# London Luton Airport Expansion

**8.118 Applicant's Response to Issue Specific Hearing 4  
Action 7 - Update on Road Safety Audits (Tracked Change  
Version)**

**8.118 Applicant's Response to Issue Specific Hearing 4 Action 7 –  
Update on Road Safety Audits (Tracked Change Version)**

Figure 3.1: Swept Paths - Eaton Green Road / Lalleford Road

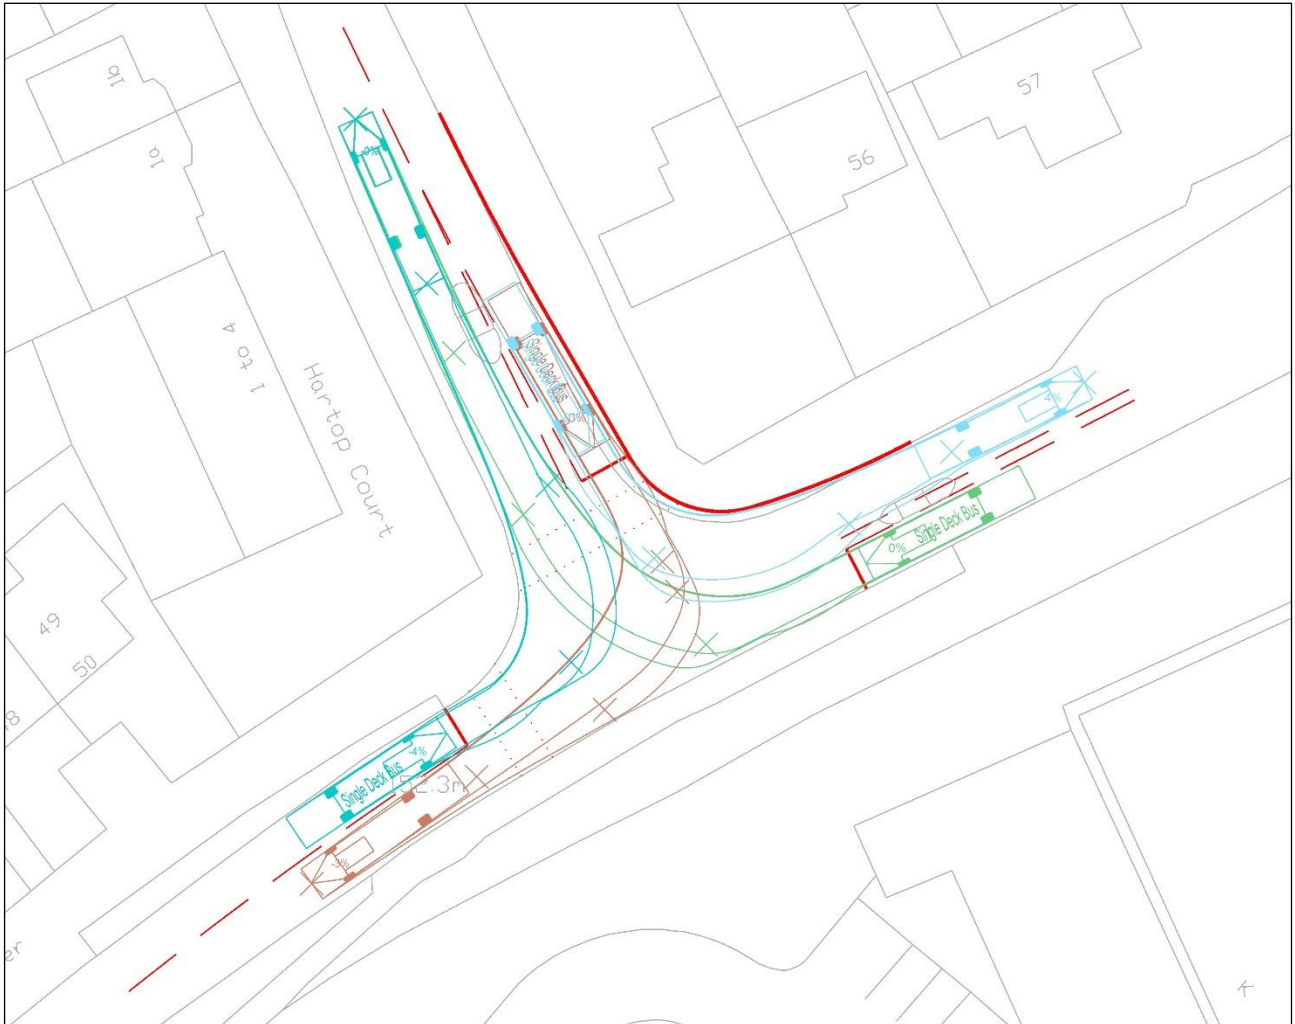
Ref.	RSA Problem	RSA Recommendation	Design Organisation Response	Overseeing Organisation Response	Agreed RSA Action
	Road is a bus route). As a result, large vehicles may mount the kerbs or strike street furniture, creating a hazard to other road users or pedestrians walking along the footway.	position of the stop lines adjusted if required.	to ensure that all manoeuvres can be accommodated without overrunning stop lines – see Figure 3.1.	checked at subsequent design stages.	at subsequent design stages.

3.2.1 Figure 3.1 above shows the swept path analysis for 12m single deck buses at the proposed signalised junction between Eaton Green Road and Lalleford Road.

Figure 3.1: Potential Pedestrian Crossing Improvements

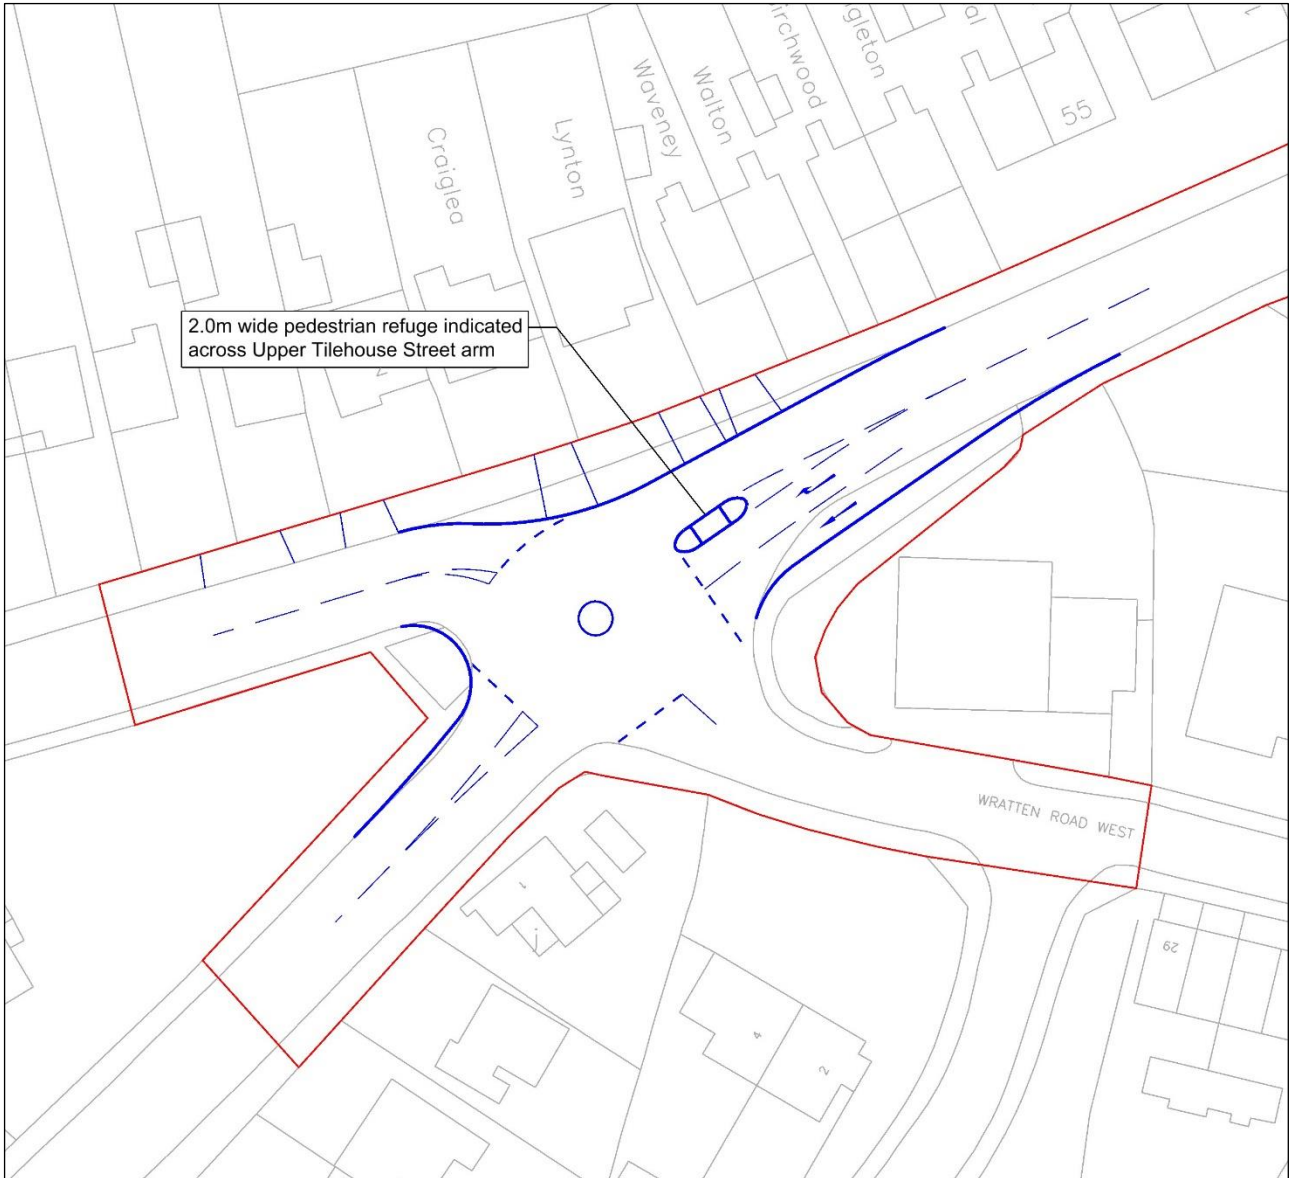
3.2	The widening to two lanes could make crossing movements more hazardous for pedestrians, especially at peak-times when traffic flows are likely to be high. This could increase the risk of pedestrians being struck by vehicles.	An uncontrolled pedestrian crossing point should be provided, with a wider physical central island specified.	Accepted. An uncontrolled crossing on Upper Tilehouse Street has been incorporated into the proposed layout as shown on Figure 3.1.	Disagree: At detailed design stage it is too late to address this issue. Pedestrian crossing facilities must be addressed at this stage in line with HCC policy.

3.2.1 Figure 3.1, below, shows an indicative arrangement to provide a pedestrian crossing on the eastern arm of the mini-roundabout.

3.2.2 Figure 3.1 shows an indicative revised junction arrangement which incorporates a pedestrian refuge across Upper Tilehouse Street. Existing residential dropped kerb accesses are also highlighted along the northern side of Upper Tilehouse Street and Pirton Road, in the vicinity of the junction.

Figure 3.1: Existing Tree Locations – A602 Park Way

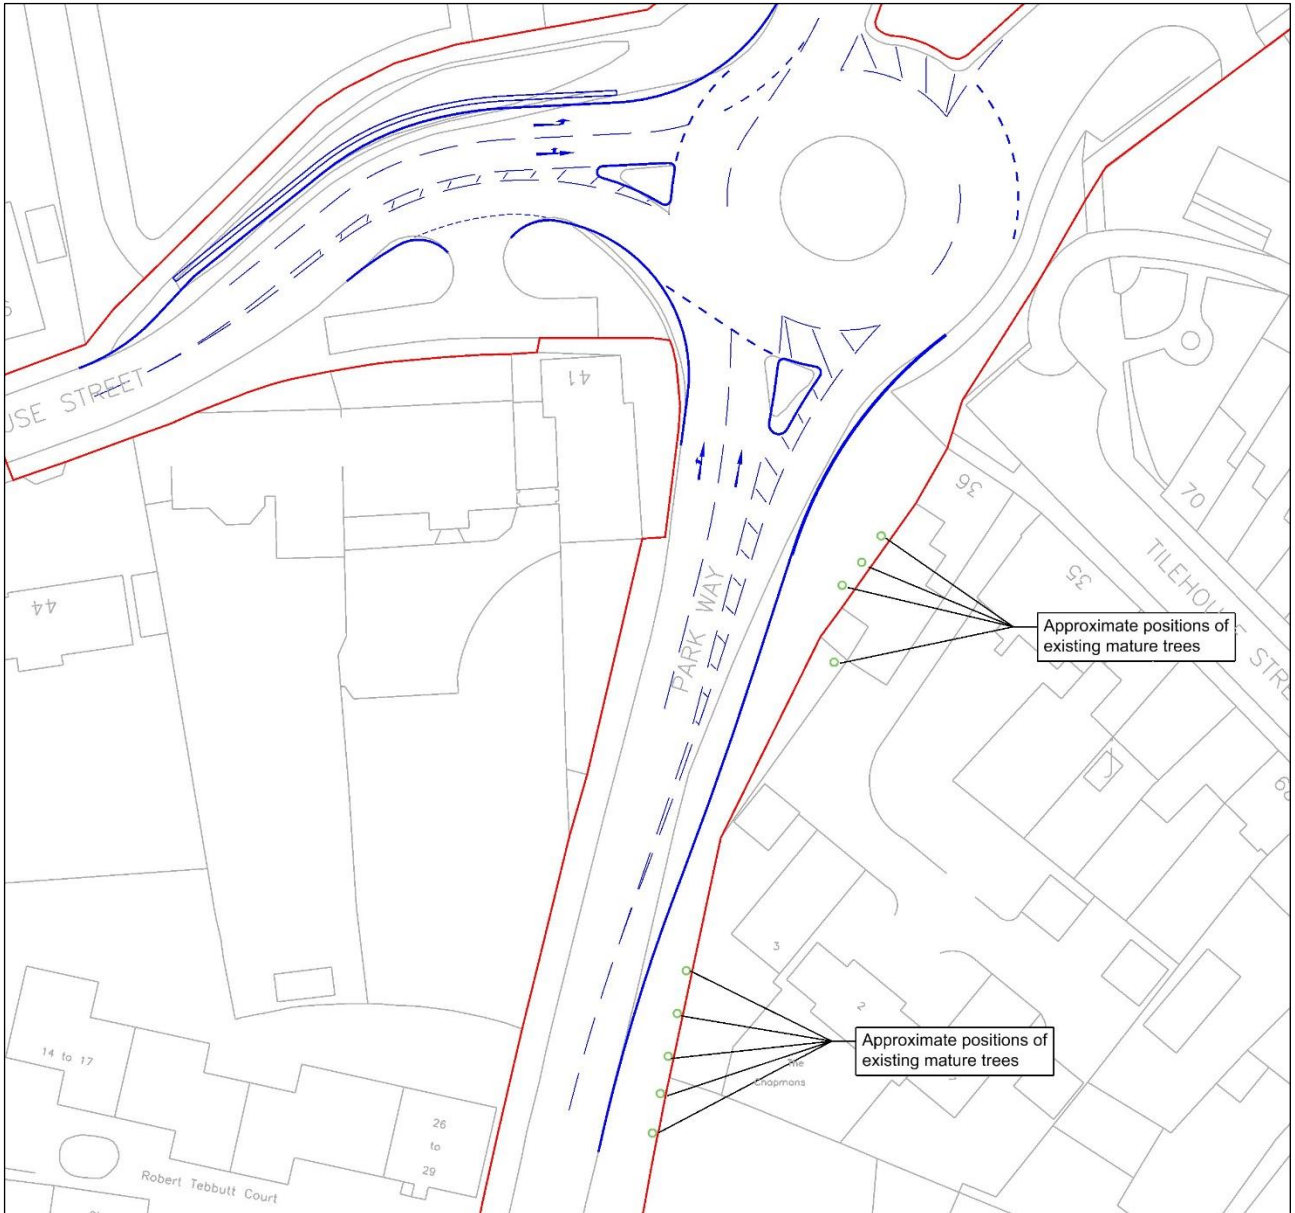
3.2	There are mature trees, dense vegetation, signs and lamp columns on the eastern side of Park Way, that could be impacted by the carriageway widening works. If these items are positioned close to the edge of carriageway, there could be an increased risk of them being struck by errant vehicles, resulting in injury to road users.	It should be ensured that any dense vegetation and mature trees are removed if they are likely to be positioned close to the edge of carriageway and other items of street furniture relocated as necessary.	Accepted. Figure 3.1 shows the indicative locations of mature trees in the area where road widening is proposed. The mature trees are within the Hitchin Conservation Area but do not have Tree Preservation Orders. They are generally located close to the highway boundary and would not be close to the widened road carriageway edge. It is not therefore expected	Disagree: Mature trees are unlikely to be removed to make way for these works. Further scheme detail will be required to show which trees are affected: This may change the nature of the scheme, easily leading to it being undeliverable. In short, the designer organisation response is not feasible/practical solution.

3.2.1 Figure 3.1, below, shows the existing tree locations along the eastern side of A602 Park Way, together with the proposed Order Limit.

Figure 3.1: Existing Tree Locations

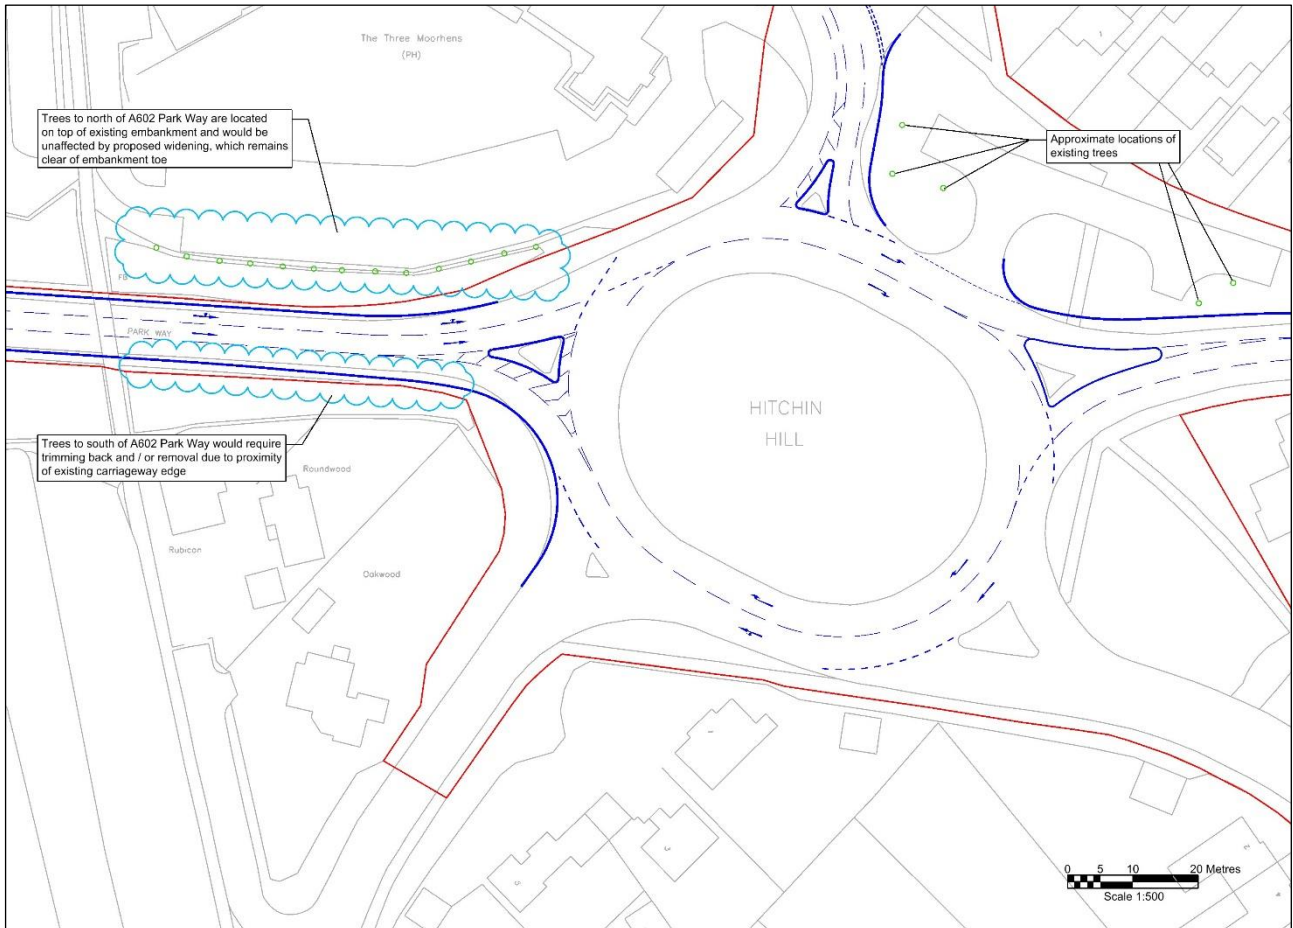
3.2	There are mature trees, dense vegetation, signs and lamp columns on Park Way, that could be impacted by the carriageway widening works. If these items are positioned close to the edge of carriageway, there could be an increased risk of them being struck by errant vehicles, resulting in injury to road users.	It should be ensured that any dense vegetation and mature trees are removed if they are likely to be positioned close to the edge of carriageway and other items of street furniture relocated as necessary.	Accepted. Figure 3.1 shows the indicative locations of mature trees in the area where road widening is proposed. The trees are not within the Hitchin Conservation Area (HCA) and do not have Tree Preservation Orders.  The trees on the north side of A602 Park Way are on an embankment and are set back from the road carriageway edge where it is not therefore expected that the trees would need removing. On the south side, it is likely that some trees	Disagree: Mature trees are unlikely to be removed to make way for these works. Further scheme detail will be required to show which trees are affected: This may change the nature of the scheme, easily leading to it being undeliverable. In short, the designer organisation response is not feasible/practical.

3.3	<p>There are numerous heavy-duty items of street furniture, such as lamp columns, utility cabinets and a telegraph pole, in addition to mature trees, that will be impacted by the carriageway widening works. If these items are positioned close to the edge of carriageway, there could be an increased risk of them being struck by errant vehicles, resulting in injury to road users.</p>	<p>It should be ensured that street furniture is relocated, and mature trees removed as necessary as part of the widening works.</p>	<p>Accepted. Figure 3.1 shows the indicative locations of mature trees in the area where road widening is proposed. The trees are not within the Hitchin Conservation Area (HCA) and do not have Tree Preservation Orders.</p> <p>Nevertheless, there is flexibility in the design of the Hitchin Hill approach to move the kerblines away from the closest trees by reducing the lane widths and/or the central hatched area – this is shown on Figure 3.1.</p> <p>The mature trees on the north side of the A602 westbound approach are</p>	<p>Disagree: Mature trees are unlikely to be removed to make way for these works. Further scheme detail will be required to show which trees are affected: This may change the nature of the scheme, easily leading to it being undeliverable. In short, the designer organisation response is not feasible/practical.</p>

3.2.1 Figure 3.1, below, shows the approximate locations of existing trees in the vicinity of the A602 Park Way / Hitchin Hill arms of the junction, together with a potential minor amendment to the Hitchin Hill arm of the junction to minimise potential impact on trees to the east.

Figure 3.4: A1081 New Airport Way Proposed Layout

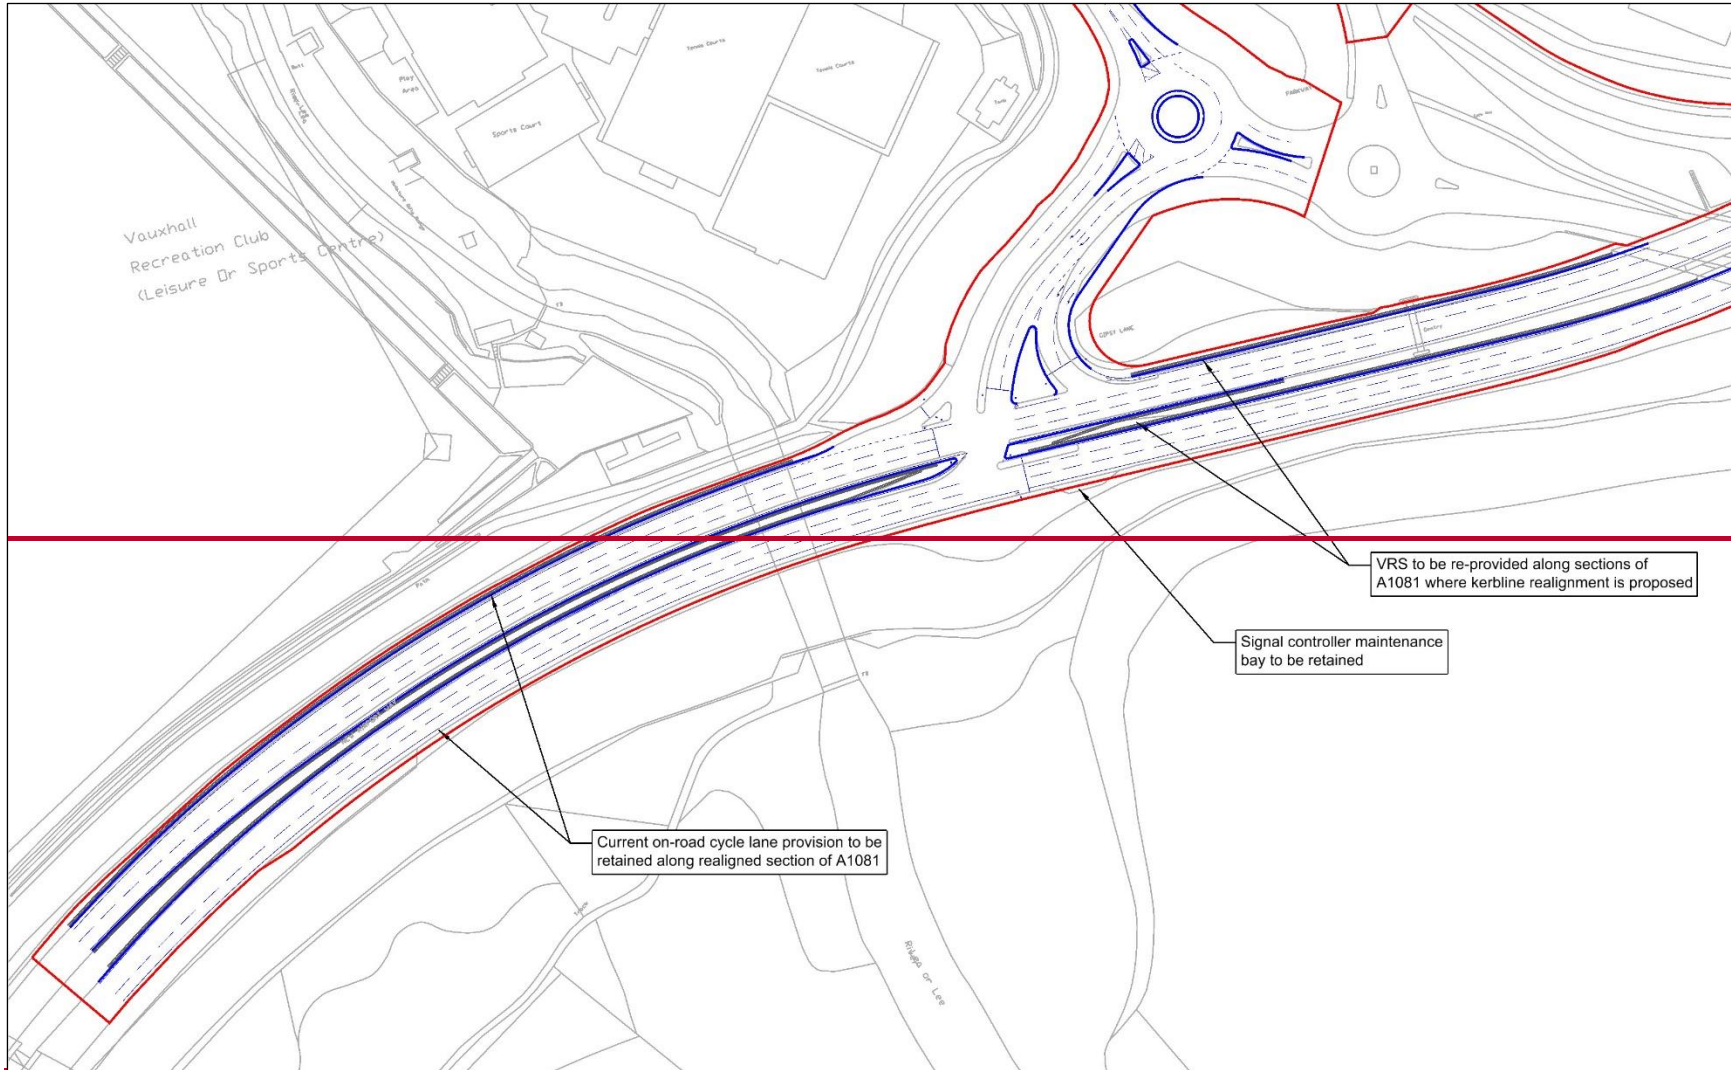
Ref.	RSA Problem	RSA Recommendation	Design Organisation Response	Overseeing Organisation Response	Agreed RSA Action
			<p>lanes on the A1081, there are only two left turn lanes entering the A1081, which means a parallel left turning car would still be able to enter the offside lane of the A1081. To guide vehicles, white lining would be provided as shown on Figure 3.2.</p> <p><u>In paragraph 4.3.2 of the Traffic Signs Manual Chapter 6 (Traffic Control) it says "Lane markings may be laid within the junction where some guidance for drivers would be helpful, although care should be taken that the meaning is clear to drivers on all approaches. There should be no risk of giving the impression of a Stop or Give Way line to transverse movements. The arrow to diagram 1038.1 (S11-4-21) may be used to indicate a route through a junction."</u></p> <p><u>The Book of Reference [REP9-007], Streets, Rights of Way and Access Plans [REP10-008] and Schedule 4 of the DCO [TR020001/APP/2.01] have been amended to reflect that the area of land that is outside the CBC highway</u></p>	<p><del>with an adjacent left turning ear.</del></p> <p><del>CD123 states that the design of signal control junctions should incorporate turning radii for the largest design vehicle, and that provision should be made for appropriate corner radii and associated tapers, to allow for the turning of Heavy Goods Vehicles.</del></p> <p><del>As such the swept path analysis demonstrates the need for further revisions to the layout as per the Safety Audit recommendations, in order for a HGV to turn left without straddling lanes, which would appear to require the provision of a corner taper. It is unclear if this can be achieved within the DCO limits or the extent of available public highway.</del></p>

~~3.4.2 Figure 3.4, above, shows the proposed design of the A1081 New Airport Way, which demonstrates that the existing cycle facilities can be retained within the proposed layout. The existing signal maintenance layby to the south of the junction is also retained in its current location. VRS is indicated along both sides of the A1081 and within the central reserve area, which would need to be re-provided in areas where the kerblines are proposed to be amended.~~
